6672A-13

Modification Recommended Service Note

6672A DC power supply, 0-20 V, 0-100 A, 2000 W. GPIB

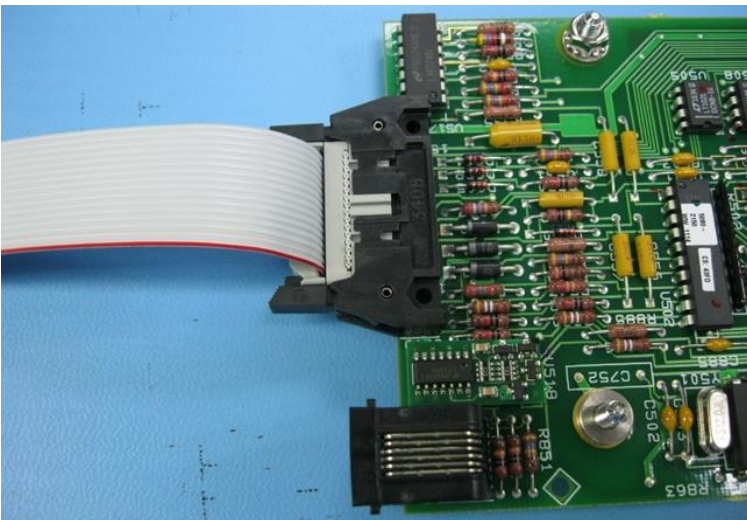
6. Replace with a new PCA board (06672-61020).
